REFERENCE: **B004-19 BPUB Remodel of the Existing Administration Building Restrooms Renovations Project**

## ADDENDUM NO. 01

**BPUB Restrooms Renovation Project**  
**BROWNSVILLE PUBLIC UTILITIES BOARD**  
ERO Project No.: 16002A

## **ADDENDUM 1 NARRATIVE**

03 MECHANICAL FIRST FLOOR HVAC  
RESTROOM PLAN  
1/4" = 1'-0"

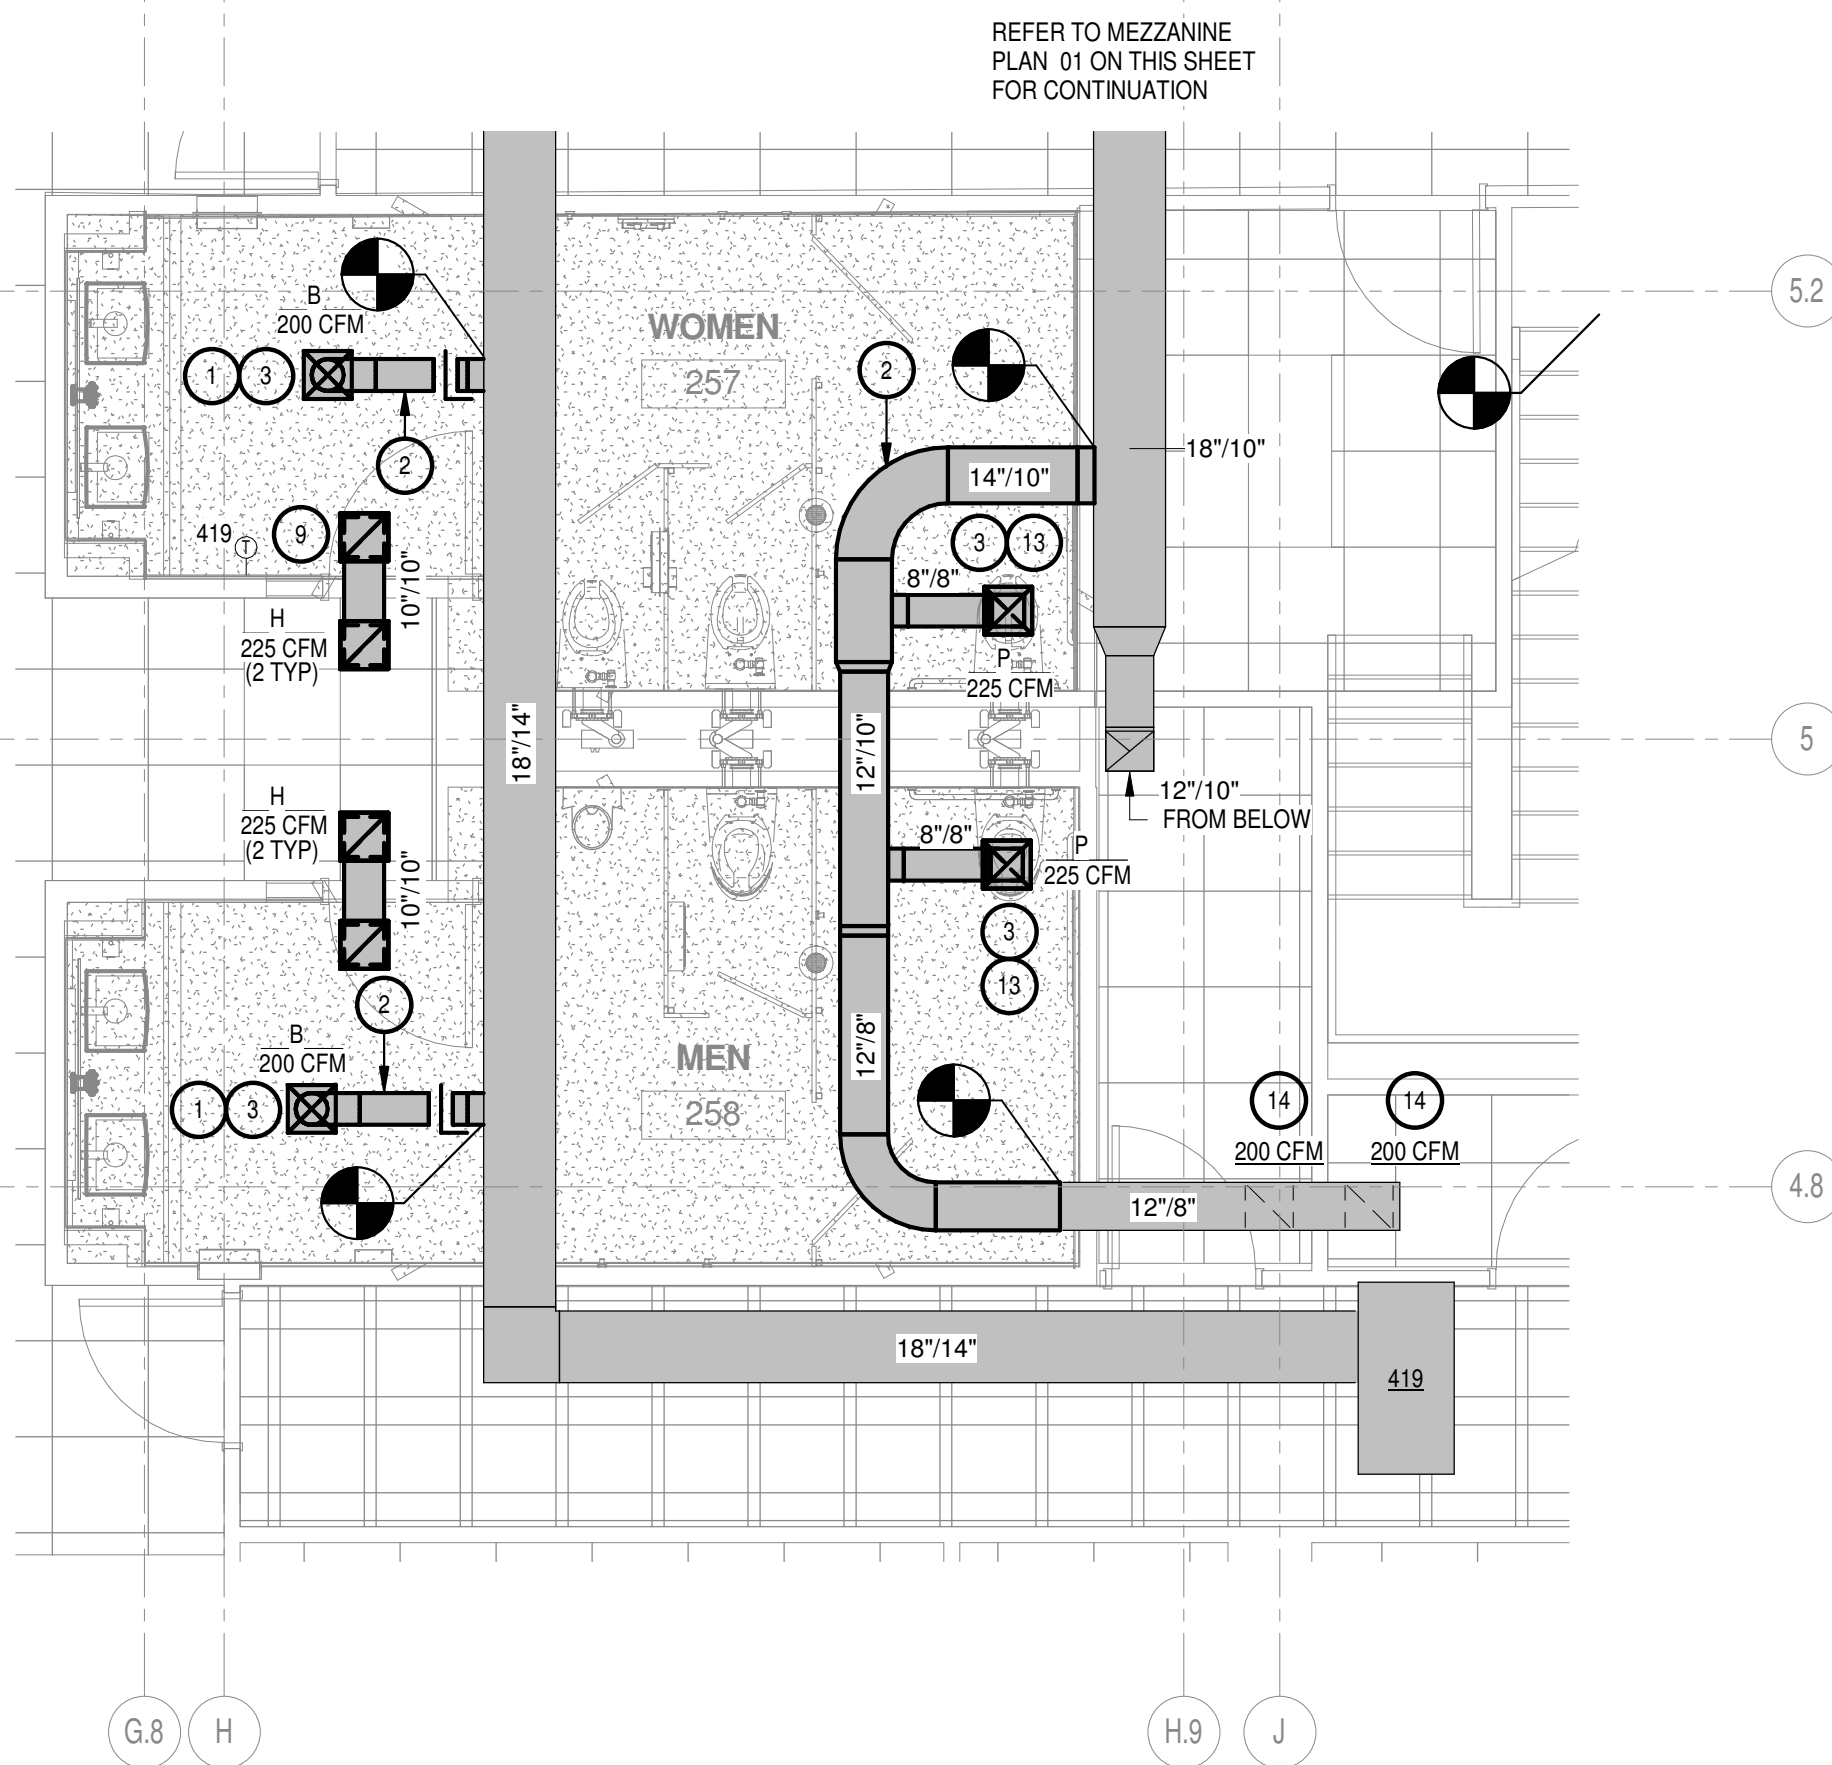
- a. Moved legend down to make key note 15 legible.
